## Change Order Proposal

COP No.	Date
019	4/3/2023

Provide material and Labor to construct picnic shelter at Meadowdale beach park. Design and permitting by others. The county has previously increased the contract time so an extension is not required for this work.

<b>Contract Number</b> PW-002-21SB	<b>Project Name</b> Meadowdale Beach Park & Estuary Restoration	<b>Owner</b> Snohomish County DCNR/Parks
---------------------------------------	--	---

**PICNIC SHELTER STRUCTURAL PLANS**

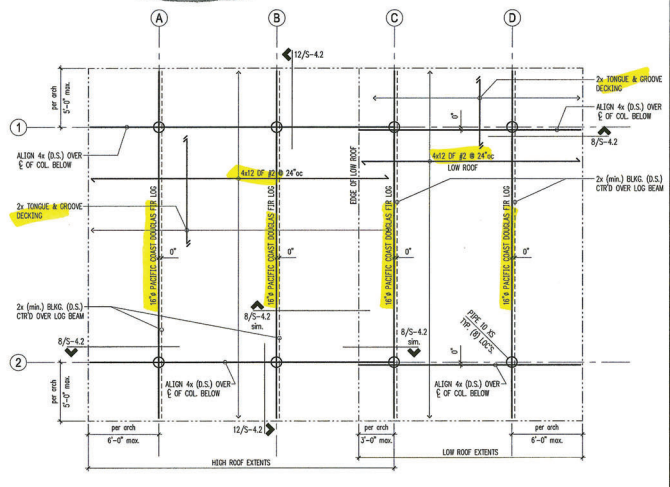
Highlighted Logs, timber, decking  
by RLD
